NHTSA SAFETY RECALL

Safety Recall Notice #06V-305 EHC Replacement

P/N 170-000001-00 EHC REPLACEMENT INSTRUCTIONS Recall #06V-305

EHC COMPARISON

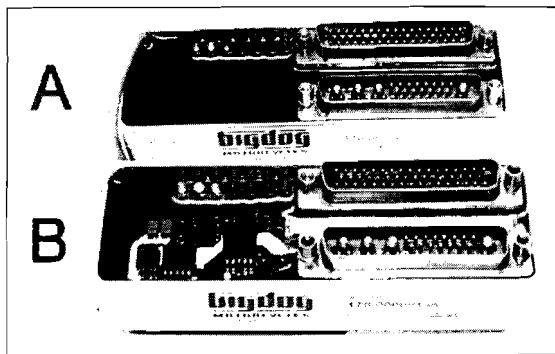
IMPORTANT: Replace the EHC of ANY Big Dog Motorcycle model having an EHC, P/N 170-000001-00 with clear, gel-type potting material. Remove that EHC and replace with P/N 171-000010-00.

NOTE: This recall does **not** affect EHC's P/N 170-000001-00 with **black** potting material.

- A. 170-000001-00 with **black** potting material.
- B. 170-000001-00 with **clear** potting material.

TYPICAL – Fill these areas (1) to top of pins with dielectric grease, filling all areas (2) to remove air gaps.

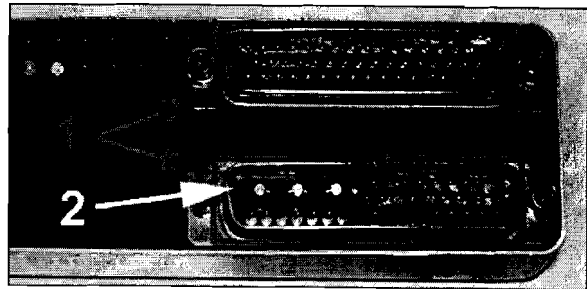
3. Unscrew the four connector screws from the backbone and power harnesses and pull the two connectors off and away from the EHC.
4. Remove the two nylon nuts from the EHC studs and remove the EHC.
5. Inject dielectric grease (P/N 270-000009-00) into the power and backbone harness connector ports of the replacement EHC. Fill to top of pins. Smooth dielectric to remove air gaps.

NOTE: Install in reverse order, making sure that the two nylon nuts are not tightened more than **15 in•lbs**. Harness connector jack screws should be tightened evenly from side to side until the connectors seat.
